Frodsham's Active Travel team's response to Solar farm application.

Summary of response by Frodsham's Active Travel team.

Objectives and approach to method of mitigation.

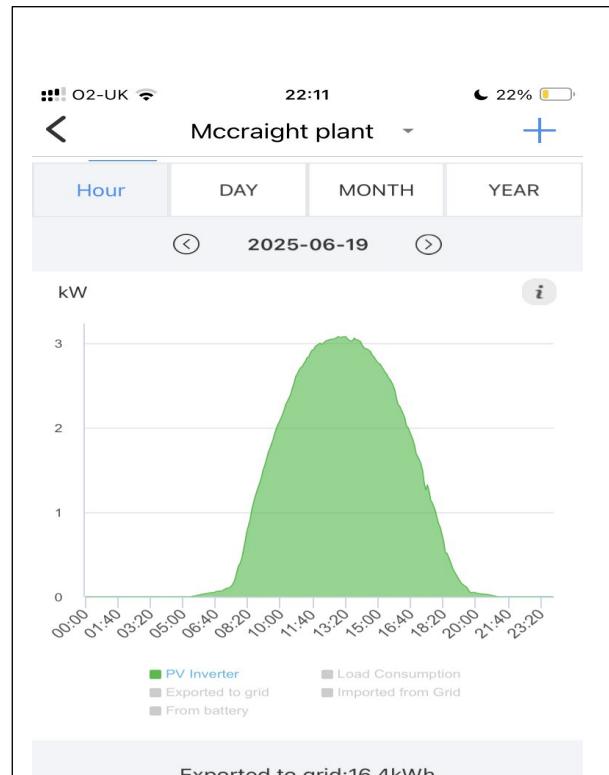
- i) to place natural screening in front of the panels to a high proportion of the panels.
- ii) to place this screening in such a way that it breaks up what is visible from the hill of what is a vast array into irregular areas which look less unnatural.

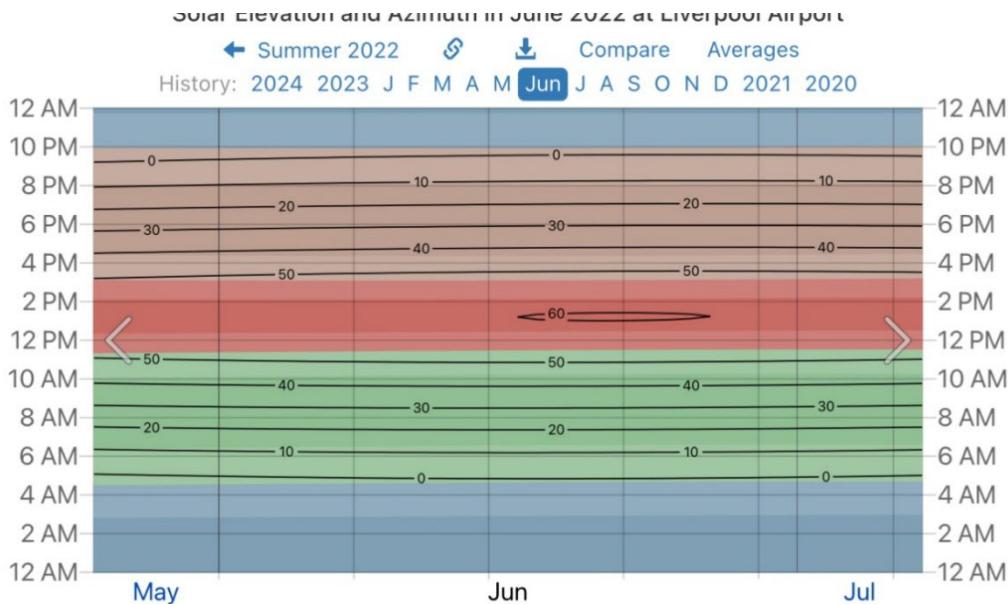
Examination of the power output curve shows that virtually no electricity was generated before 07:30 am. This is to be expected as the sun will be at low elevation and in the east, at right angles to the panels and will be approaching the panels at very low intensity. At about this time however power begins to be generated at an increasing rate as the sun moves both southwards and in front of the panels and its elevation increases. Comparison of this time with the published data for the sun's elevation (June 2022) at Liverpool airport shows it to be approx. 20° at 07:30.

Screening could be sited in front of solar panels, without significant loss of PV output, so long as they do not block out sunlight approaching the panels at an elevation of 20° or higher.

Illustration of impact of 7m & 8m tree screens on sun's access to solar panels in mid-June.

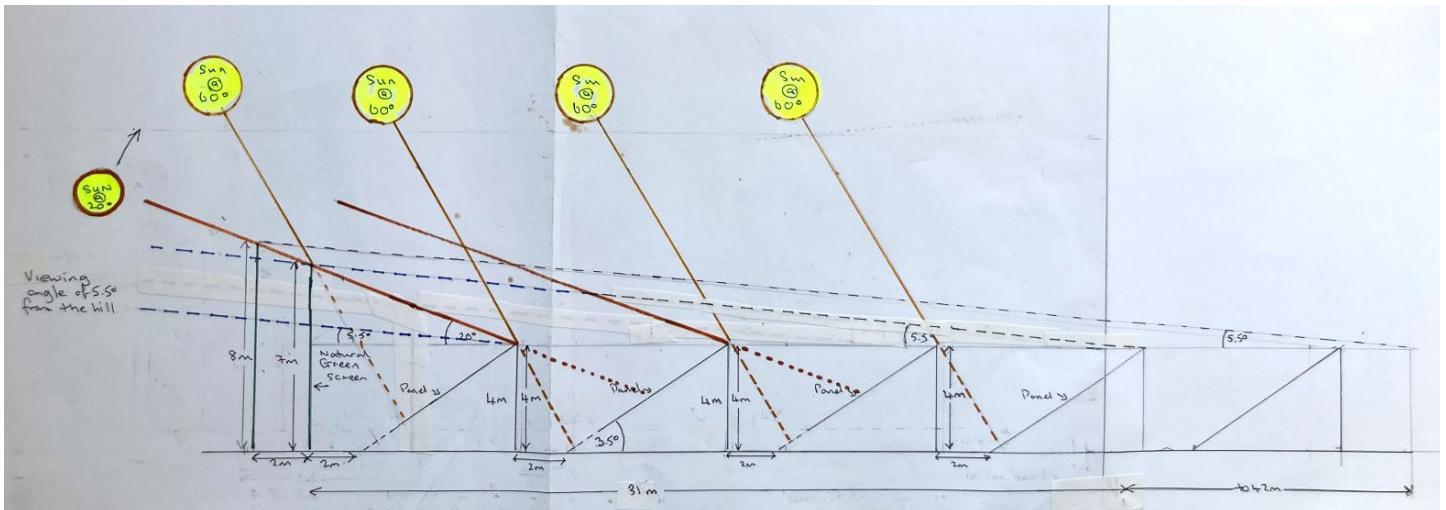
Recognising the importance of this to the community we reviewed Table 1 in the applicants [Design Parameters statement](#) and learned that the rows of panels are up to 4m high; can be as close as 2m and will be angled at between 10^0 – 35^0 to the horizontal. The scale drawing below illustrates this for the highest, most upright and closest configuration and shows the viewing angle from the top of Frodsham hill is 5.5^0 .

Evidence is available, with calculations, in Appendix 1, which shows that locally the sun barely generates any power at angles less than 20°. Even at this angle the drawing shows that a large area of all panels behind the front row will be screened by the panels in front of them. i.e. the applicant's design includes a high level of screening which would prevent power generation even when the sun is less than 20°.

Recognising this fact, placing a tree screen in front of each row, the top of which presented an angle of 20° to the front panel, would not affect the solar power generated for all but the front row. For illustration purposes, the diagram illustrates how 7 or 8m high screens can be as close as 2-4 m respectively, to the front row. As trees naturally have different sizes & shapes, suitably shaped trees would need to be placed in front of each block of arrays such that a 20° angle was maintained.

Importantly the illustration shows that, as the viewing angle from Frodsham hill is only 5.5° for the nearest array of panels, a row of 7-8m high trees would screen from view approx. 31-42 m of the panels behind the front row of panels. This screening benefit would increase to approx. 70-93m for the most distant panels and the extent of screening would be approximately doubled when viewed from Helsby hill.

We contend that major changes are required and could be achieved by :

1. Use of natural screens of trees, bushes and shrubs in front of each section of panels.
2. Varying the heights of the natural screens over a range of 7- 8m and also varying the distances from the front of the panels and the width of the screens.
3. Frequently softening the straight lines and edges of the rows of panels.
4. Leave open areas within the largest sections of panels and create small copses of trees and bushes.
